Structural Statement for the proposed alterations to the former anti-chambers alongside the Rochdale Canal at Victoria Mill, Manchester.

I, Anthony Clarke, a Conservation Accredited Structural Engineer have been asked to comment on the ADS proposals to repair the external chambers to Victoria Mill, in Lower Vickers Lane, Manchester. They occur at the lower ground floor alongside the Rochdale Canal.

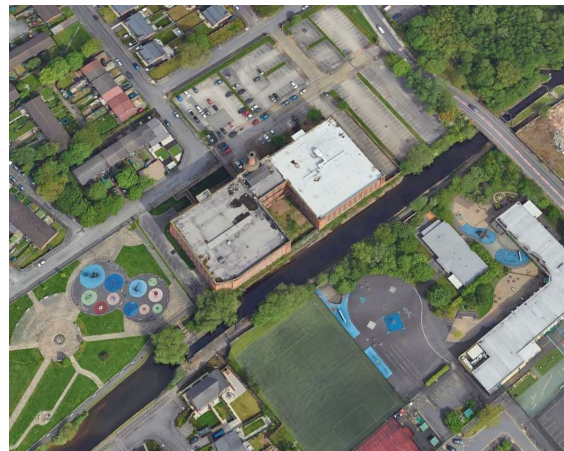
From photograph No 2 I can see that:

- Floor beams span across the warehouse onto the external wall alongside the canal. The wall at the canal level is punctured by a series of openings leaving a series of pillars typically 5 bricks wide and deep at 3-4m apart.
- A curved wall (on plan) extends outside the line of the external wall to create the chamber. I understand that the wall is inclined to the vertical: This is a typical construction technique for buildings of this warehouse's age. The curved wall will be structural in that it resists the pressure of the canal water across the opening. The wall has been rendered. The render appears to be in a poor condition. I presume that the main body of the wall behind is masonry construction.

- The base of each of the chambers occur above the lower ground floor level, leaving a band of brickwork on the external wall line. I estimate that the lower ground floor level is approximately 2.5 - 3m below the canal walkway. A narrow chase has been formed in each bay in the lower wall section. Originally this may have accommodated a drainage outlet.

- From the above photographs it is not possible to tell the condition of the external wall of the chamber masonry. There is evidence of slight movement of the masonry below the floor beam bearings but elsewhere in the visible section of the wall, the masonry appears satisfactory. I presume that ADS will undertake their own detailed inspection of each chamber and the external wall.

- I note that there is a one brick wide arch over the opening to the chamber at canal water level. The external wall above must rely for its support on this arch acting in conjunction with the ground floor structure.

- The lower ground floor appears wet alongside the chambers but elsewhere the floors are relatively dry. This is probably rainwater entering the open roof space of the chamber. Typically canals relied on either puddled clay or asphalt applied to the external face of masonry buildings to act as a waterproofing membrane. Neither are visible in the photographs. The render is unlikely to be capable of preventing water ingress.

- a. Checks are made to establish the type of render that exist on the chamber walls. Originally it is likely that this wall either had no render or a lime based render was applied. This type of render is relatively easy to remove and will allow for checks to be made on the type of mortar used within the presumed chamber brickwork. If the render has been more recently applied then it is probably a cement based render: Such renders are difficult to remove and often bring the face of the brick with it. This will reduce the structural capacity of the wall.

- b. A sample of the existing mortar should be removed from the inside face of the chamber wall and be sent to a laboratory for constituents part analysis.

- c. Each of the chamber walls need careful examination.
 - The junction of the chamber wall with the warehouse external wall should be checked for integrity of bond. If found to be unbonded then install stainless steel stitch dowels across the joint and repoint the face.

- Any horizontal cracking should be checked to establish the cause. There may be embedded ironwork that is corroding.
 - Any local rebuilding of the wall should use brickwork of a similar strength and water absorption to the base brickwork. The masonry should be set in a mortar compatible with the findings of item b) above.

- d. The introduction of a reinforced concrete capping beam to the perimeter of the chamber, as shown on the sketch, will help to restrain the head of the wall and allow for fixing of handrailing. The level of this beam needs discussing further with the architect. Consideration should be given to dowelling the capping beam into the warehouse external wall as well as to the top of the chamber wall. All such dowels should be stainless steel bars fixed into site drilled holes and secured using an appropriate resin to suit the moisture content of the brickwork.

- e. The detail shows a new external concrete slab in the base of the chamber. I would suggest that trial holes should be excavated to check the level of the base of the inclined wall. The base of the existing inclined wall or the warehouse, external wall should not be undermined by any part of the new construction.

- f. The substrate at the formation level of the slab's sub-base needs checking in each location. if the substrate is solid brickwork, then the slab should bear onto a concrete blinding. If the substate is a filled ground, then the slab should bear onto visqueen onto a sand blinded granular hardcore compacted in place.

- g. The top face of the new lightwell slab should be laid to a fall towards the new drainage gulley.

- h. Depending on the integrity of the waterproofing to the existing construction and or the canal, this base slab may be subject to an upward pressure. Consideration should be given to dowelling this slab into the chamber's wall and the slab / reinforcement be designed to resist an assumed head of water pressure. This may require an engineering judgement to be made.
- i. The type of waterproofing membrane needs to be discussed further with a specialist supplier based on the findings of item a) above and the required level of waterproofing.
